BYLONG COAL PROJECT

Environmental Impact Statement Response to Submissions

BYLONG COAL PROJECT

RESPONSE TO SUBMISSIONS

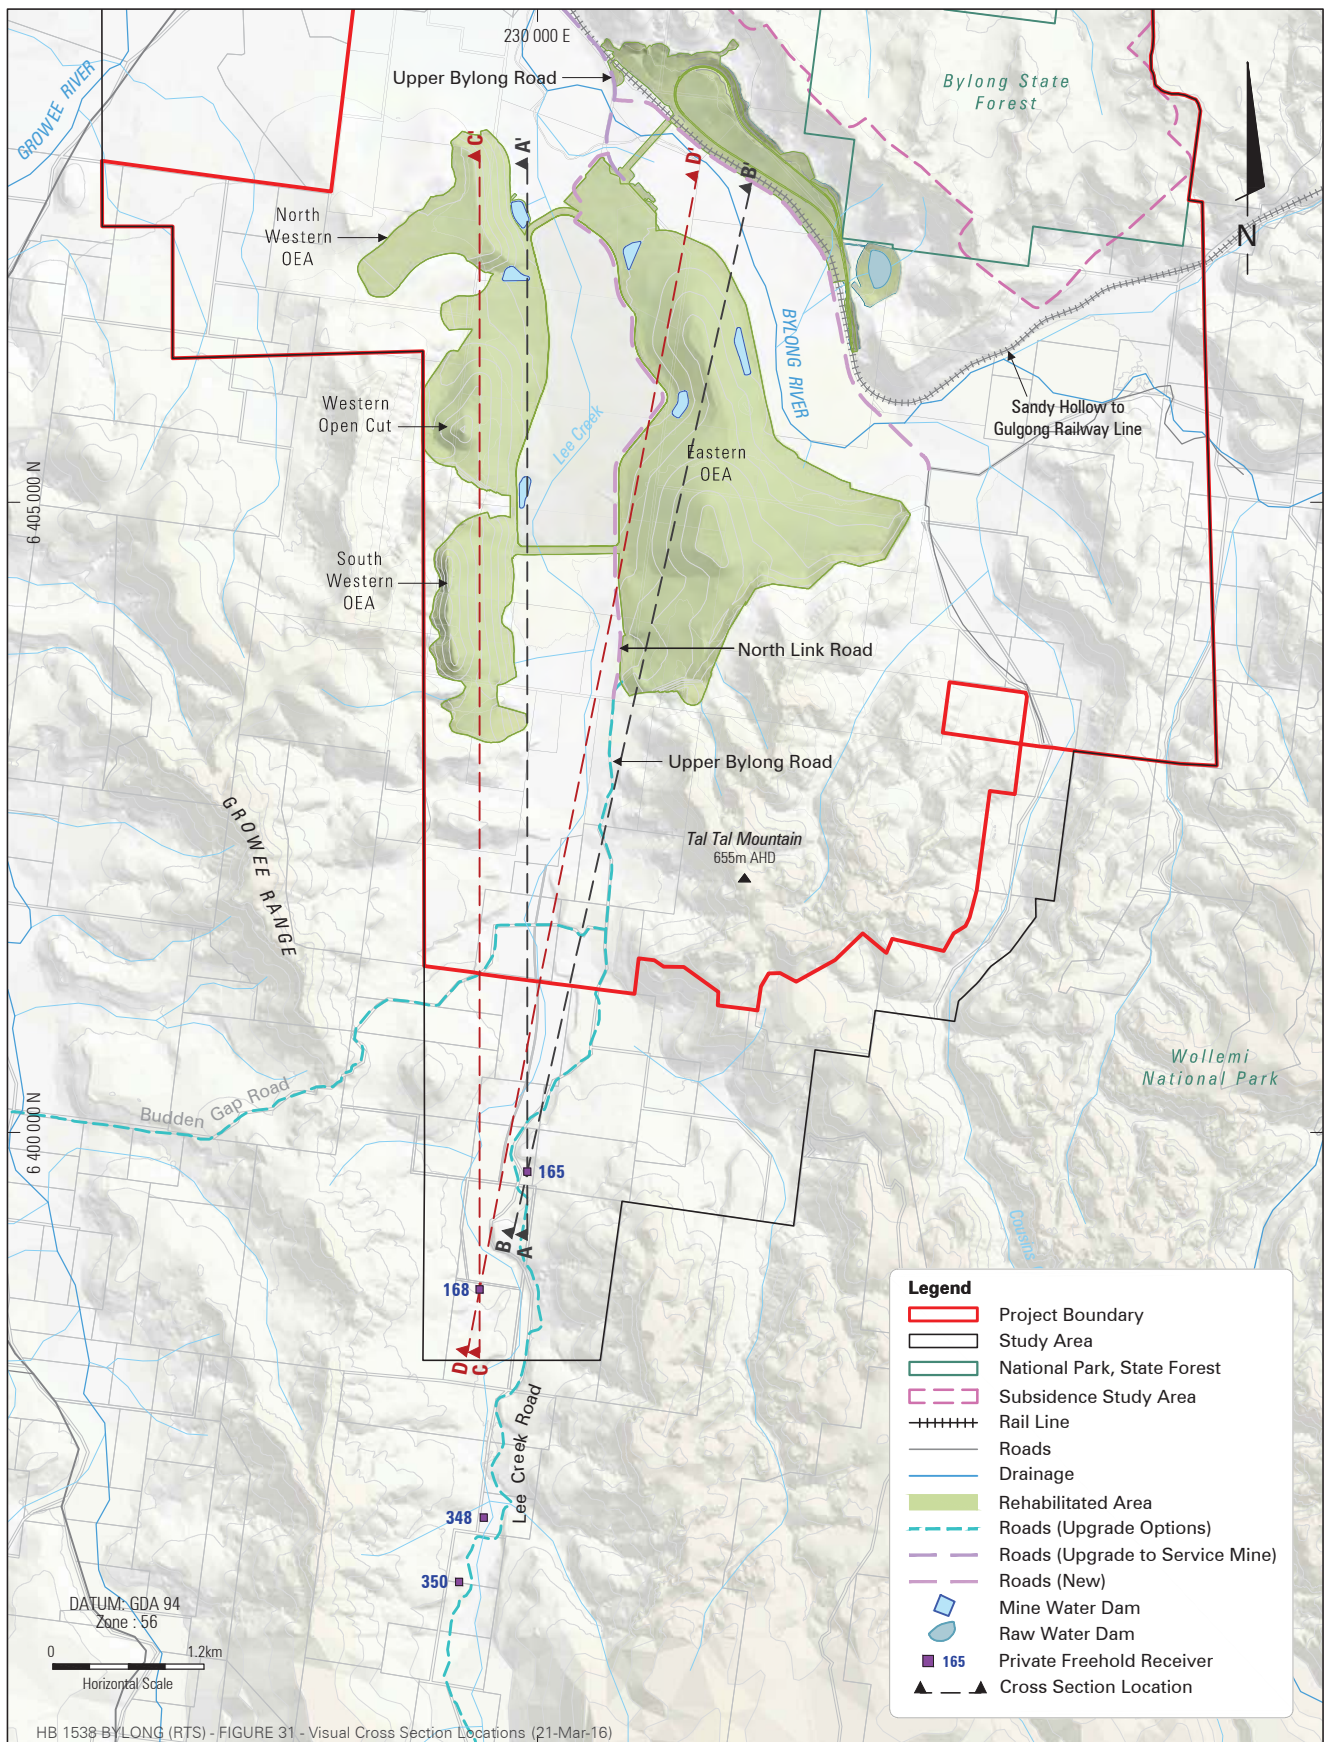
The submissions referenced above raised concern that the EIS does not include any visual representation of the adverse impact on vistas and views from any property or place in the southern quadrant of its visual impact analysis.

The Garling / Loneragan family property (Receiver Numbers 165, 168, 348 and 350 on Figure 12a of the EIS) represents private freehold properties located south of the Project.
